December 11, 2018

**Re: Public Comments Submitted on Behalf of Impact and Anna Ortiz Regarding Draft
Renewal Permit/Compliance Plan 50343/ISWR No. 31547, Authorizing Renewal of
Hazardous Waste Permit**

Figure 2 RAP Showing Groundwater PCLE Inside PMZ

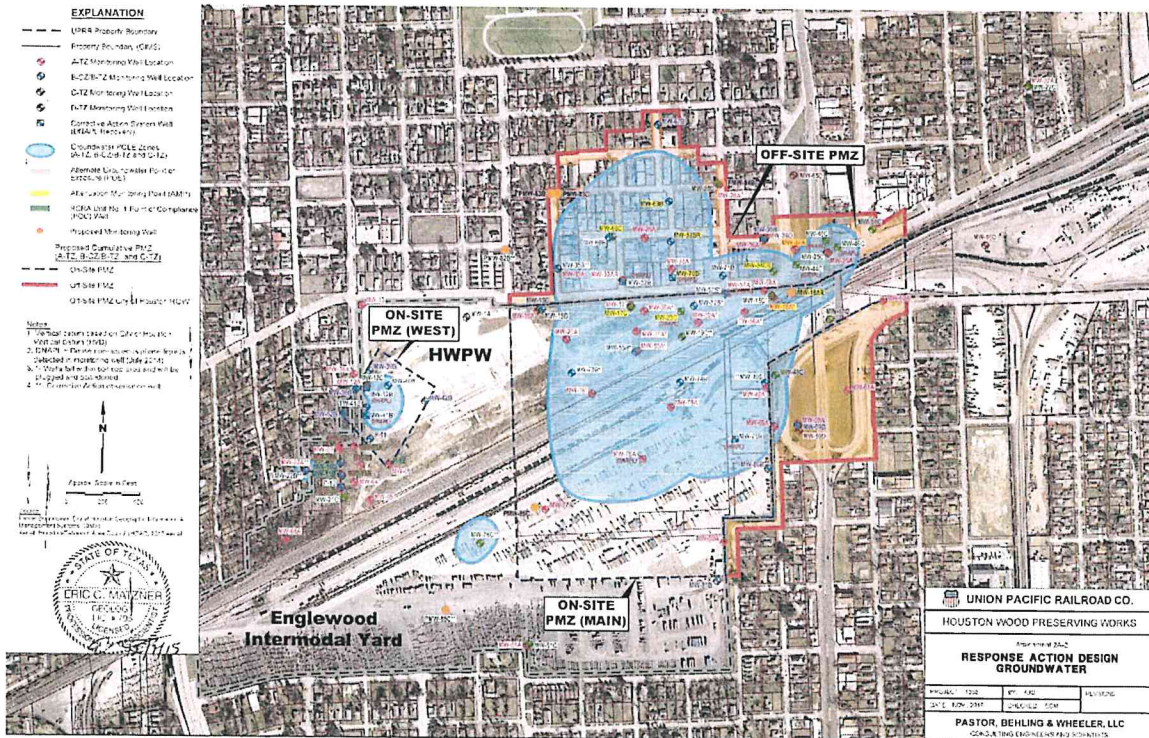
Lone Star asserts that Union Pacific has failed to adequately assess subsurface and groundwater conditions, both on and off-site, and that by doing so Union Pacific's application fails to demonstrate that its RAP will prevent the post-closure escape of waste, contaminants, leachate, run-off, or decomposition products to the surrounding environmental media as necessary to protect human health and the environment, as required by RCRA regulations and TCEQ rules.²⁷ Specifically, the RAP fails to show that humans will not be exposed to concentrations of COCs above the PCLs. The failure to assess the site puts in doubt any representation by Union Pacific that the contamination plume is stable or that it has been delineated properly. Without more confidence in the stability and extent of the contamination plume, the Permit Renewal/Compliance Plan is not ensuring the long-term integrity of public health and the environment. Figure 2 below shows what Union Pacific believes to be the physical extent of the PCLE inside the PMZ.

It is the accuracy of the PCLE Zone that is in doubt. Lone Star asserts the PCLE is unstable and is therefore larger and more extensive than what Union Pacific has represented. The following irregularities with the Renewal Permit/Compliance Plan all point to Union Pacific's failure to adequately assess the Site:

Figure 5 Cone Penetration Technique Data, IM-CPT-02

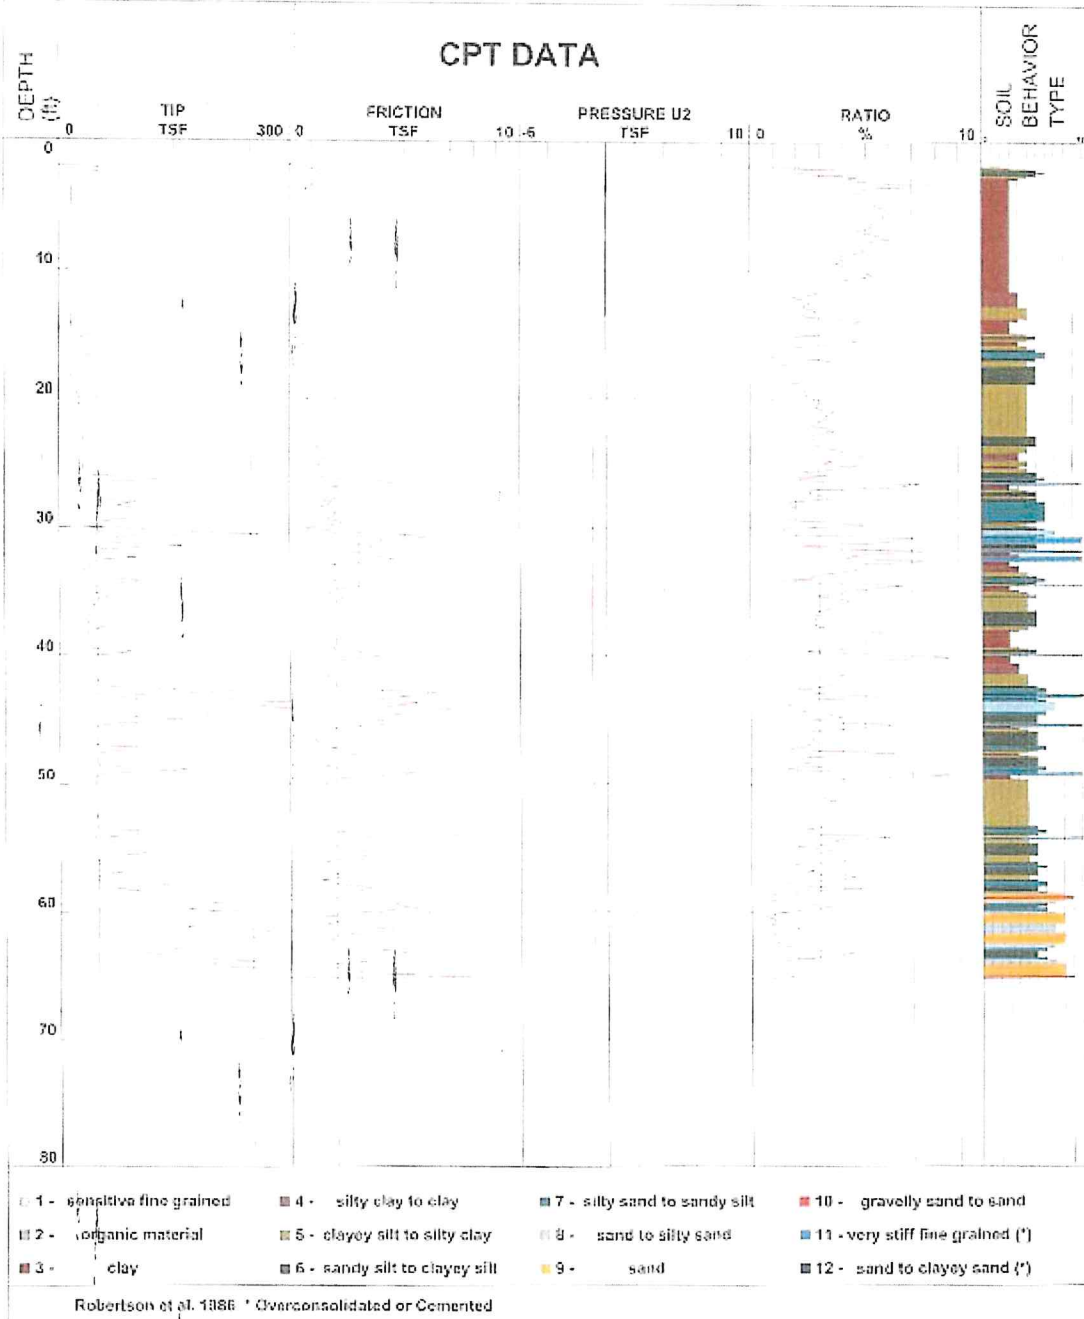
Data produced by Union Pacific demonstrates that oversimplification of the subsurface conditions into alternating layered zones is contrary to the actual subsurface conditions. First, Union Pacific's boring logs concerning the subsurface conditions collected in early 2013 were seemingly ignored later in 2014 when Union Pacific presented multiple cross sections showing the subsurface as a layered system as part of its initial application. The boring logs below show what two of the twenty-two samples taken using the Cone Penetration Technique ("CPT") at the Site demonstrate in the subsurface. The logs show the various subsurface soil types and the elevations at which they are found.

The CPT is a widely used and trusted technique for characterizing subsurface conditions and soil types. The work done by Fugro identified multiple types of soils using the CPT including clay, silt, sand, and gravelly sand, as well as other soil types, all of which are described as being varying combinations of the aforementioned soil types. A total of 10 different soil types were identified in the 22 samples by Fugro using the CPT.³³ A proper understanding of the CPT data compiled by Fugro is that the subsurface conditions are made up of little layers of mixed soil type characteristics with no one soil type being consistent across the Site horizontally. Although the CPT data may seem complex, it is not. The CPT suggests that the subsurface is best understood as a single saturated unit or zone that is made up of distinct soil types. None of these soil types are uniform across the site, and are therefore accurately described as “lenses.”

Figure 7 Cross Section A-A' & B-B', first half

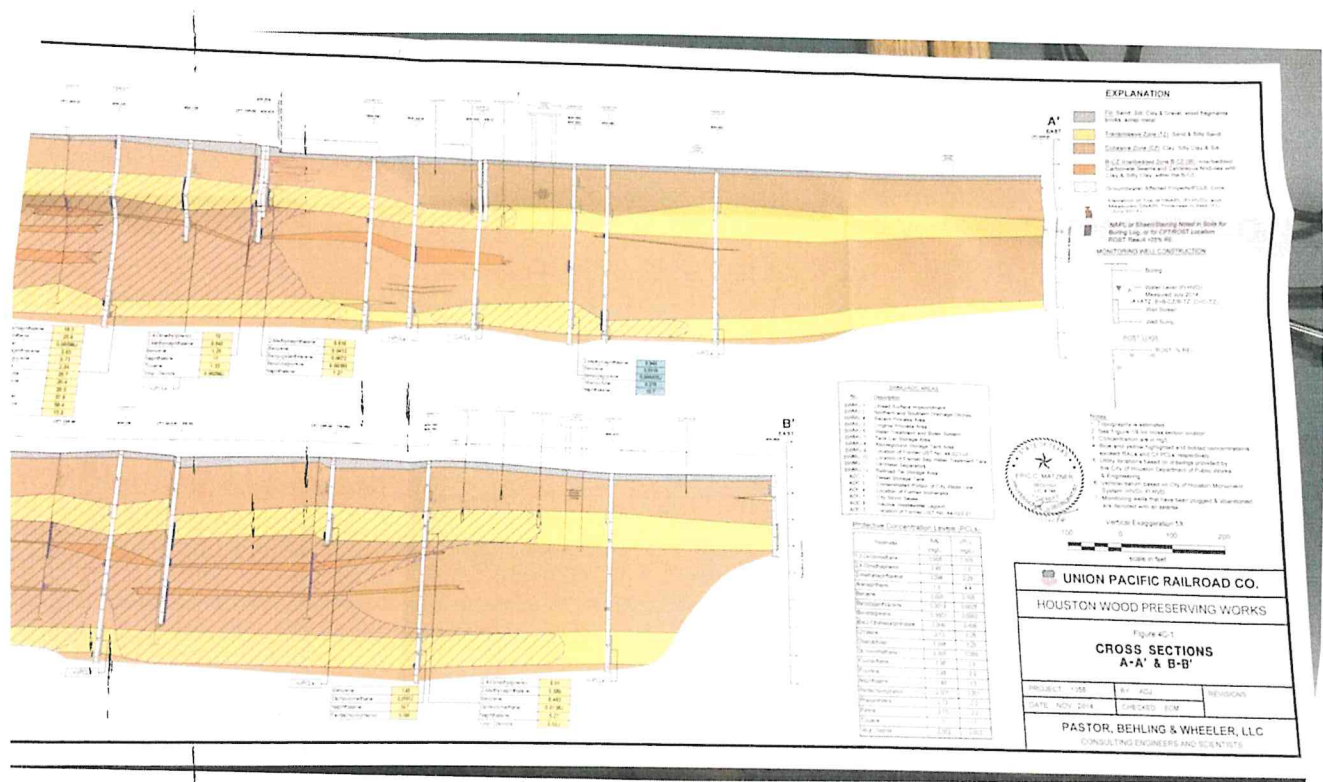
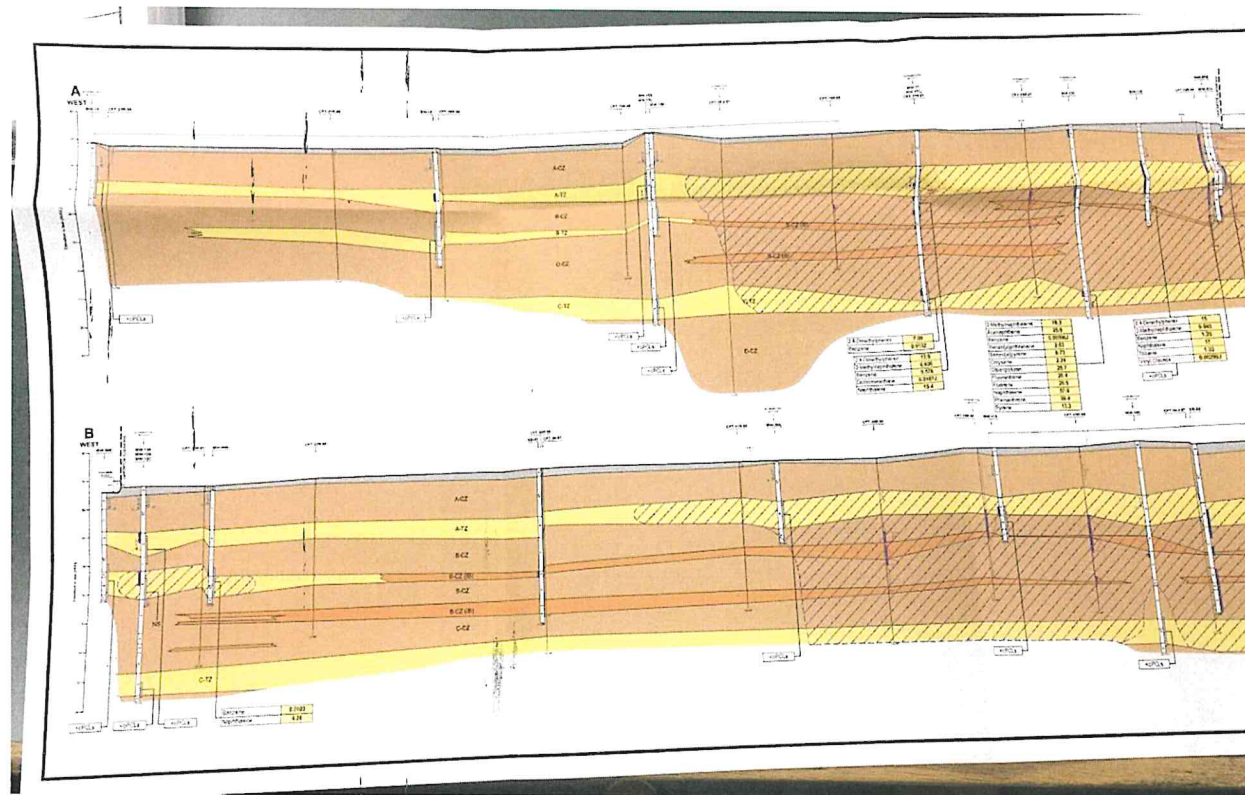
After collecting this CPT data, it is supposed to be used in a way that informs the cross-sectional maps, which are to be as accurate as possible demonstration of subsurface conditions. When properly done, the cross-sectional maps would show subsurface conditions that are closely aligned with the CPT data. That is, the cross sections should show a subsurface that is made up of about ten different types of soils at varying elevations across the site. Instead, Union Pacific has supplied cross sections like the ones below, which indicates that Union Pacific ignored the 2014 Fugro data:

As can be seen in Figures 7 and 8 above, Union Pacific oversimplified the subsurface conditions, which constitutes either a mischaracterization of the data that had been collected earlier, or its complete omission when making these cross sections. Union Pacific has instead chosen to present and argue that the subsurface conditions are layered, that the layers are not interconnected, and that any contamination plume found in any one layer is not influenced by, nor is capable of influencing, the contamination found in another layer. This is directly contrary to what is suggested by the Fugro that was collected in 2014. Therefore, any assumptions about the contamination plume that is based, even partially, on the oversimplified, layered, presentation of subsurface conditions are therefore poor assumptions are rebuttable. This includes the conclusion that the contamination plume is stable and not expanding.

Figure 9 Conceptual Site Model S-N

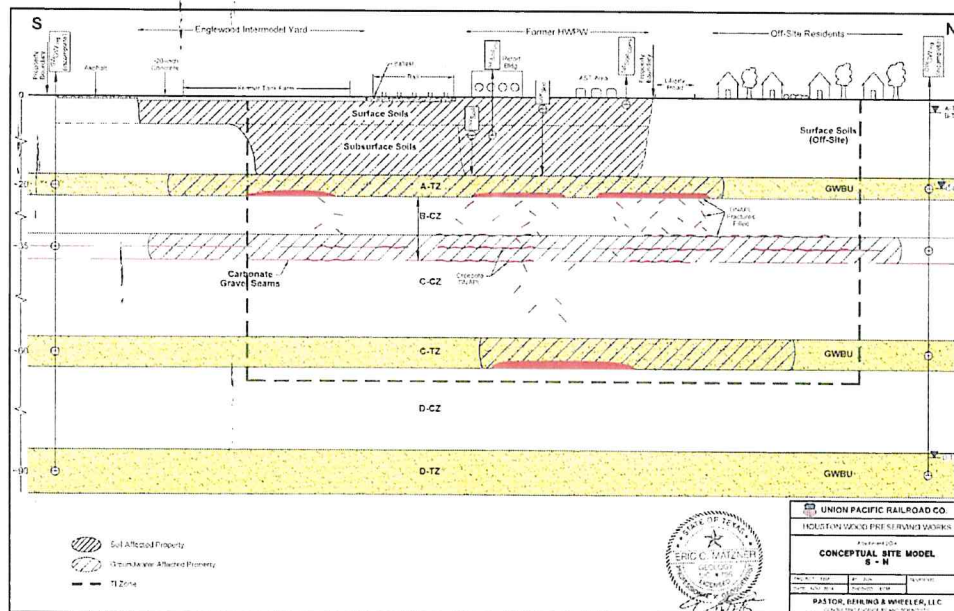
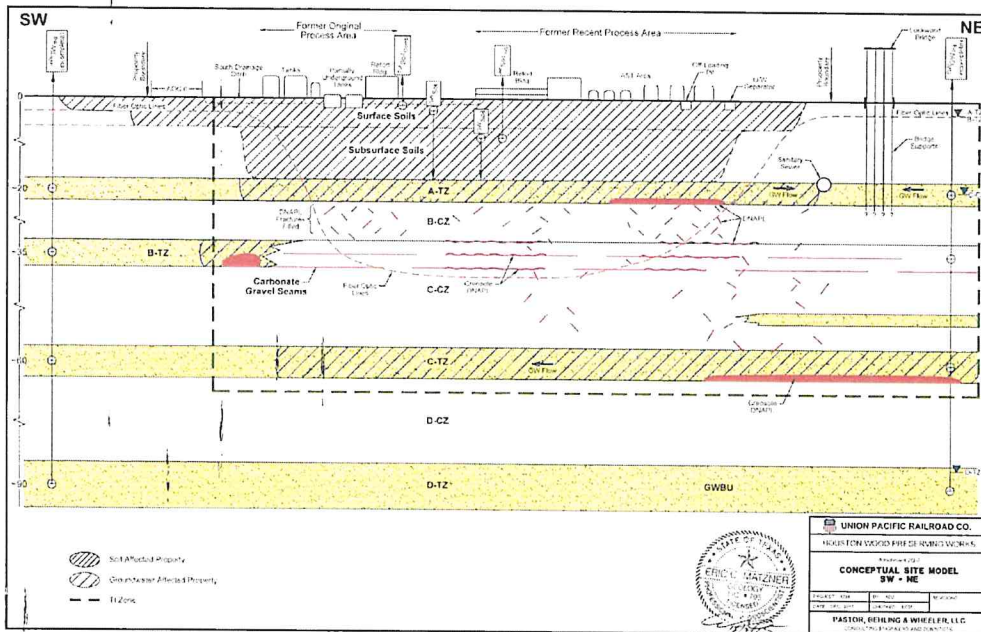
Union Pacific has supplied conflicting data about the ability of carbonate seams in the subsurface to stop the downward movement of DNAPL. First, figures supplied by Union Pacific clearly show that DNAPL in the "A" layer and "C" layer are capable of penetrating or otherwise passing through the carbonate gravel seams that supposedly separate the "B" transmissive zone from the "C" cohesive zone. See Figures 9 and 10 below, both Conceptual Site Models.

Yet in its RAP worksheet, Union Pacific seems to suggest that the carbonate seams would prohibit the downward migration of DNAPL by stating the carbonate seams have an average hydraulic conductivity of 2×10^{-7} cm/sec.³⁷ This is internally inconsistent with the Conceptual Site Models which demonstrate that DNAPL has pooled below the carbonate seams in spite of their supposed ability to prohibit downward movement of DNAPL. The TCEQ should take this to mean that the carbonate seam is not at all capable of stopping the downward movement of DNAPL. Any representation or assertion by Union Pacific that it can control the DNAPL plume because of subsurface geology or that the plume is stable is therefore in doubt and controverted by Union Pacific's own documents.

Figure 11 PMZ Boundary Map B-CZ/B-TZ

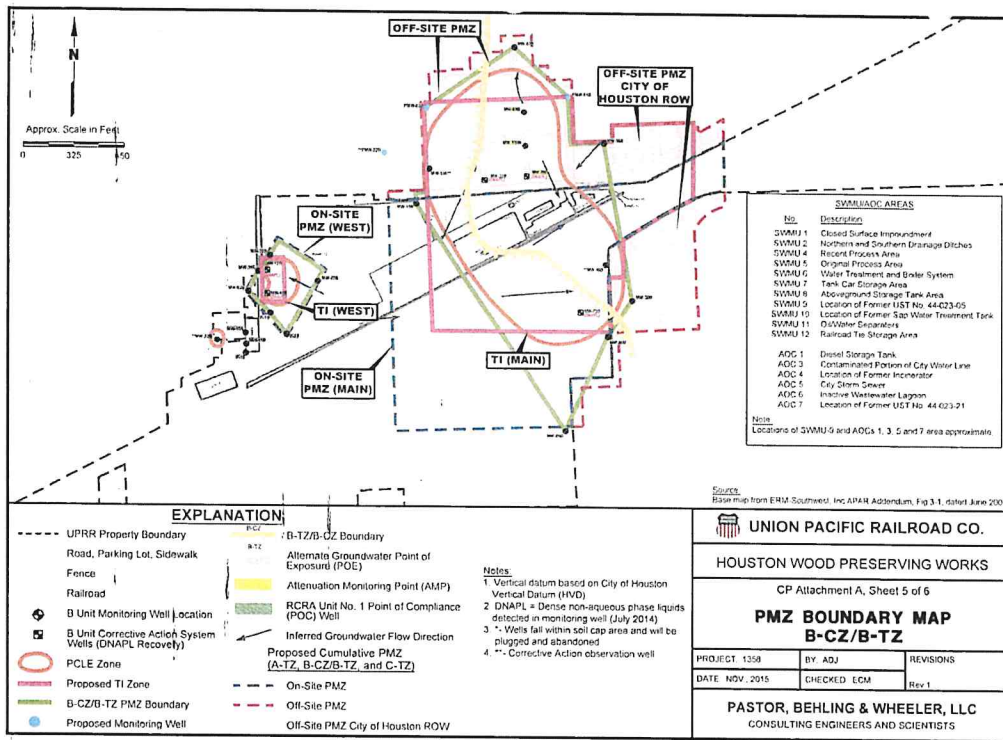
The RAP states that there is a groundwater divide on the east side of the Site, just west of the Lockwood Bridge.⁴⁰ Figure 11 below shows the groundwater divide which is also referred to as a groundwater boundary in other parts of the application materials. The RAP takes the position that this is a permanent feature yet there is no analysis that has been completed to uphold such an assumption. Groundwater divides can vary and change over time and are known to be seasonal. Without long-term data or groundwater hydrographs, the assumption regarding the divide's permanence is in doubt. In assuming that the groundwater divide is a permanent feature and justifying groundwater maps on its existence, Union Pacific is skirting its "continuing obligation to assess whether changes to local hydraulic gradients would increase the likelihood that COCs can migrate beyond the plume management zone at concentrations above the critical groundwater PCLs." 30 Tex. Admin. Code § 350.(f)(4)(F). Groundwater divides can change direction rapidly due to recharge events like hurricanes. Impact and Mrs. Ortiz would like to see Union Pacific verify the permanent existence of the groundwater divide, and account for any flow change that more than likely resulted as consequence of the historic rainfall observed during hurricane Harvey, especially as any change in groundwater flow influences the location and extent of the PMZ. Such verification will bring Union Pacific into compliance with its ongoing obligation to assess changes in local hydraulic gradients. Union Pacific should not be allowed to base any conclusion about the stability of the contamination plume on the assumption of the groundwater divide for the above stated reasons.

Also, as can be seen in Figure 11, Union Pacific has represented that there is a geological boundary between the B transmissive and B cohesive zones. Union Pacific’s documents refer to this as a “lateral transitional boundary where the B-TZ pinches out and becomes the B-CZ.”⁴¹ Although the TCEQ has stated that it agrees with the existence of such a divide between the two GWBUs, there is no physical boundary at the depositional setting of which to speak.⁴² Instead, the lateral “boundary” is better thought of as a transitional area where the subsurface changes from one soil type to another, as referenced earlier in *Part VI, Section I, Subsection B*. As was stated earlier, the subsurface is correctly thought of as one saturated unit where water is capable of flowing vertically, either up or down. The boundary cannot be considered to impair the flow of water, as Union Pacific would have the TCEQ conclude.

Figure 12 Groundwater COC Concentration Map of A-TZ, January/February 2018

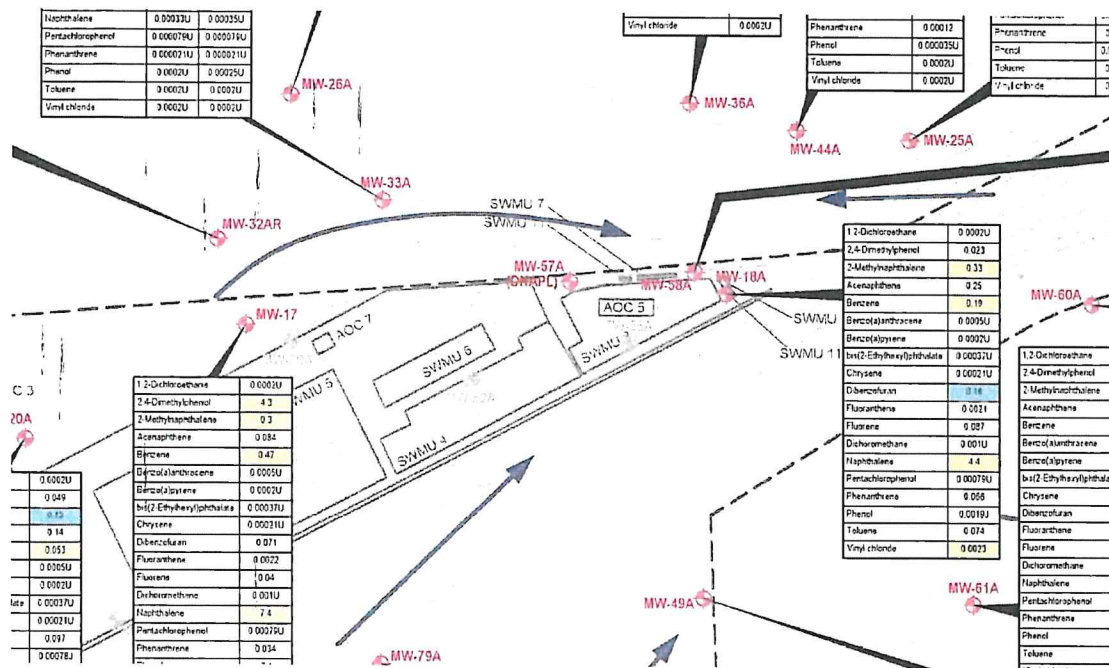
Documents submitted to the TCEQ also demonstrate that Union Pacific represents groundwater flow directions as changing over very short distances. In Figure 11 above and in Figure 12 below, the arrows in the PMZ supposedly represent the flow of the groundwater. Groundwater is not known to flow in such distinct and disparate directions over such a small horizontal distance. For this reason Union Pacific’s conclusions about groundwater flow are in doubt as are any conclusions that the contamination plume has been properly delineated and that the contamination plume is stable. Additionally, such variation in groundwater flow should act as a signal to Union Pacific that the nature of the groundwater in the area is more dynamic than previously thought and might be due to changes in local hydraulic gradients. As such, Union Pacific should be required to investigate the possible reasons behind such varied groundwater flow in order for it to demonstrate compliance with its “continuing obligation to assess whether changes to local hydraulic gradients would increase the likelihood that COCs can migrate beyond the plume management zone at concentrations above the critical groundwater PCLs.” 30 Tex. Admin Code § 350.(f)(4)(F).

Figure 13 A-TZ Groundwater COC Map Showing Sanitary Sewer Line in Green

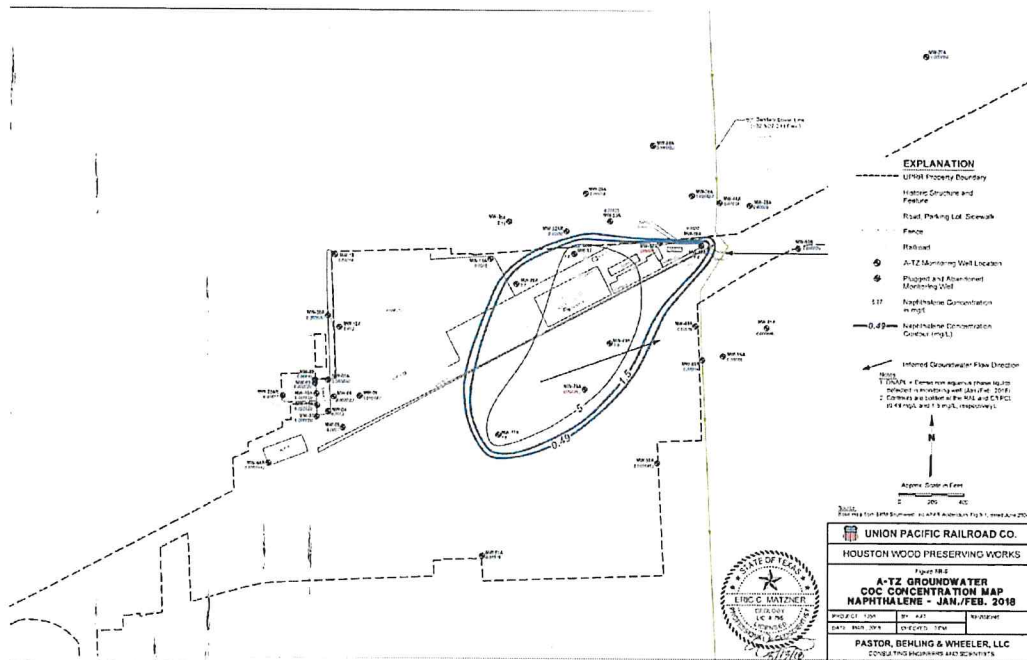
Finally, Union Pacific has failed to adequately demonstrate the absence of artificial penetrations. One pathway that has been identified for groundwater migration is a set of fiber optic communication lines (shown on Figure 10) buried underground on the site. Additionally, there is a Sanitary Sewer Line that runs north-south along the eastern portion of the Site, roughly following the path of Lockwood Drive (see Figure 13 below). Union Pacific has not demonstrated that either of these penetrations will not serve as a mode through which COCs can migrate from the groundwater PCLE zone to currently unaffected groundwater bearing units. For this reason the TCEQ must deny Union Pacific's proposed PMZ and its Permit Renewal/Compliance Plan.
